Statement

Product Name: BT&WIFI Module

Model Number: FC66E&FC66E-B

FC66E-B: FCC ID: XMR2023FC66EB

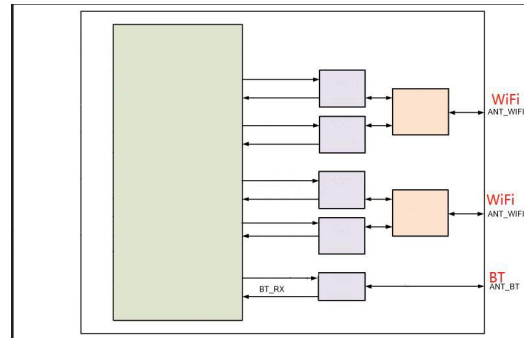
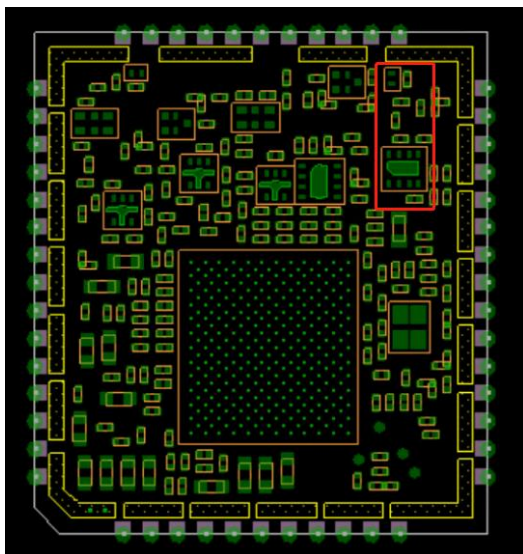
1. FC66E version is BT/WiFi0 shared antenna, FC66E-B version is BT individual antenna

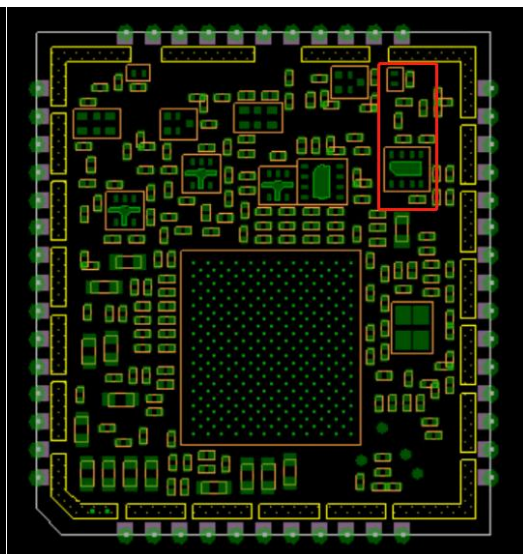
- 2.The part in the red box are mounted in the FC66E-B version.

We hereby state that there is no any other internal difference between them and the change are mounted part of Bluetooth individual antenna which won't affect the WiFi RF portions
